HISTORIC AND DESIGN REVIEW COMMISSION

HDRC CASE NO: 2019-108
COMMON NAME: 422 E NUEVA
ADDRESS: 305 S PRESA ST
309 S PRESA ST
315 S PRESA ST
317 S PRESA ST
516 S ST MARYS
512 S ST MARYS
510 S ST MARYS
508 S ST MARYS
502 S ST MARYS
LEGAL DESCRIPTION: NCB 134 BLK LOT 2 & N 7.3 FT OF 3
NCB 134 BLK LOT S 33 FT OF 3
NCB 134 BLK LOT 4
NCB 134 BLK LOT 5
NCB 134 BLK LOT 12
NCB 134 BLK LOT 11
NCB 134 BLK LOT 10
NCB 134 BLK LOT 9
NCB 134 BLK LOT 8 EXC E IRR 3.18 FT
ZONING: D, H, RIO-3
CITY COUNCIL DIST.: 1
DISTRICT: La Villita Historic District
LANDMARK: Marbach House, Medero House
APPLICANT: Mari Michael Glassel/Mark Odom Studio
OWNER: Dennis McDaniel
TYPE OF WORK: Construction of an 8-story, multi-family residential structure
APPLICATION RECEIVED: February 26, 2019
60-DAY REVIEW: April 27, 2019
CASE MANAGER: Edward Hall

REQUEST:

The applicant is requesting conceptual approval to construct an 8-story residential structure at the corner of S St. Mary's and E Nueva, which is currently a surface parking lot. The structure will feature street level retail as well a 250 residential units. The applicant has noted that structured parking will be wrapped by residential and retail space. The propo

ground floor plan

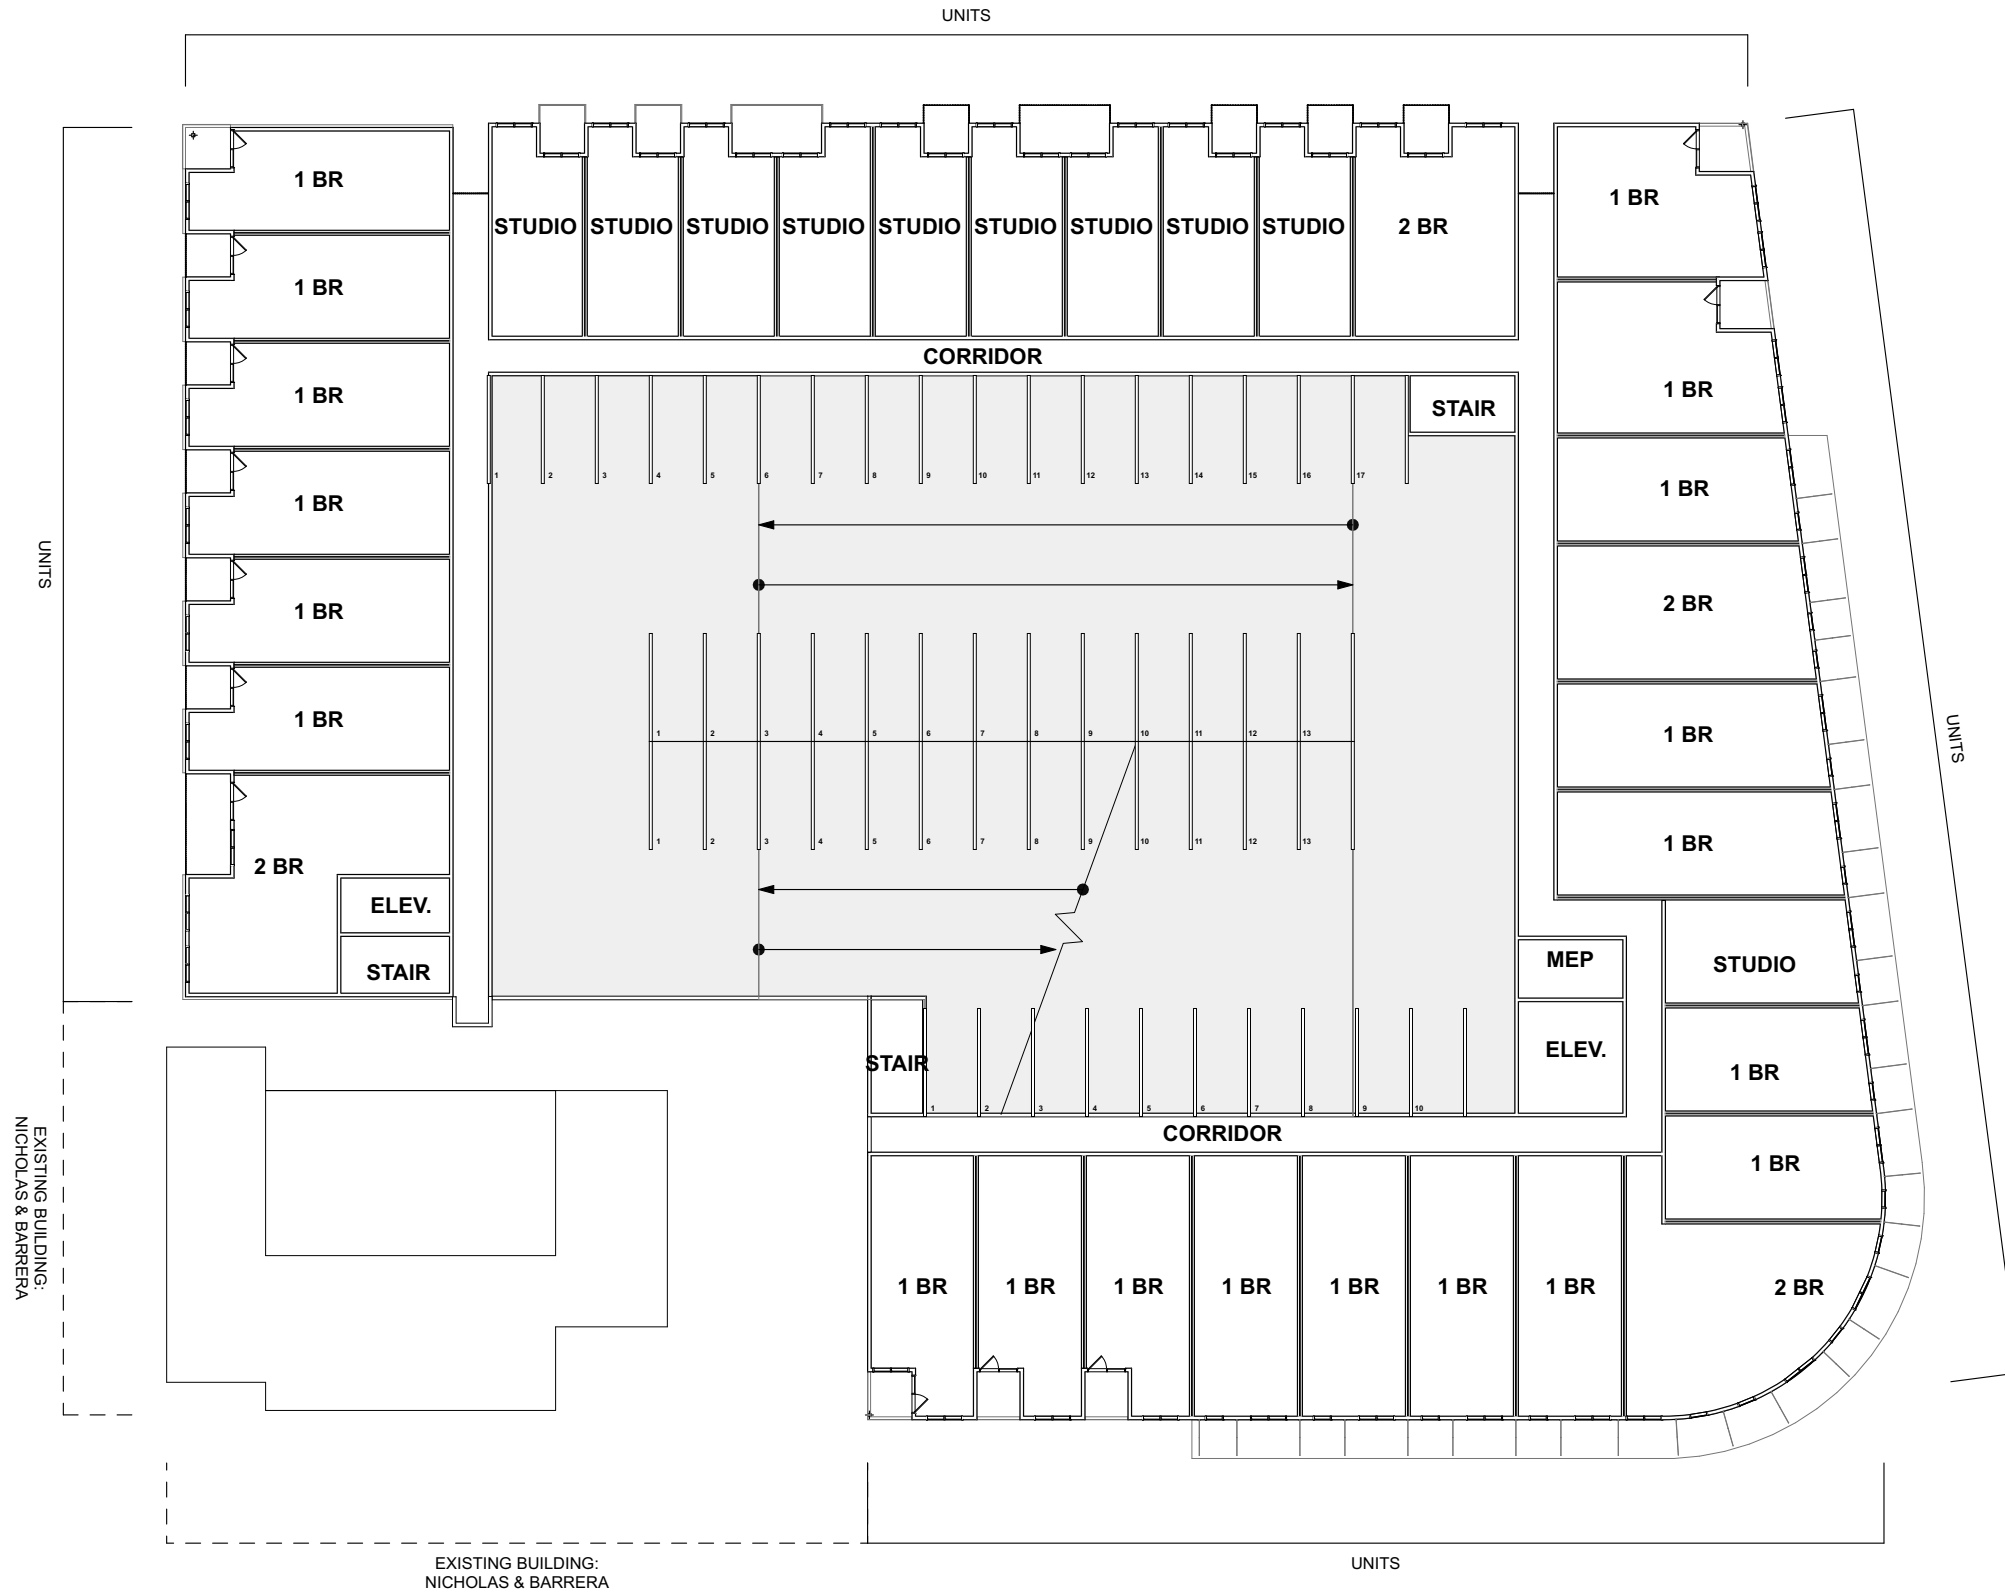
- d. **PEDESTRIAN CIRCULATION** – Per the UDC Section 35-672(a) in regards to pedestrian circulation, an applicant shall provide pedestrian access among properties to integrate neighborhoods. The applicant has proposed pedestrian sidewalks across the property to run parallel to E Nueva, S St Mary's and S Presa. This is consistent with the UDC.

- i. That the applicant provide additional information, including measurements for the proposed curb cut. The proposed curb cut should not exceed twenty-five (25) feet in width.

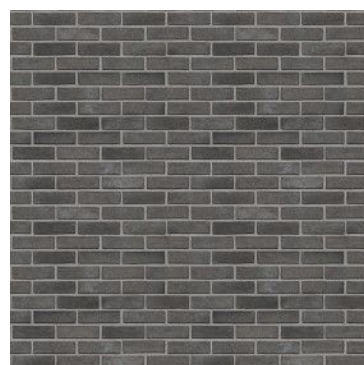
- l. **MATERIALS** – The applicant has proposed materials that include large masonry, brick, metal panels and stucco.

Staff finds the proposed materials to be appropriate and consistent with the UDC.

- o. WINDOWS – At this time, the applicant has not provided information regarding windows. Staff finds that dark colored frames that are recessed at least two (2) inches within façade planes should be used.

- v. That the applicant install dark colored windows that feature metal materials that are recessed at least two (2) inches within facades.
- vi. That the applicant submit a master signage plan for review and approval by the HDRC that includes both building and tenant signage.
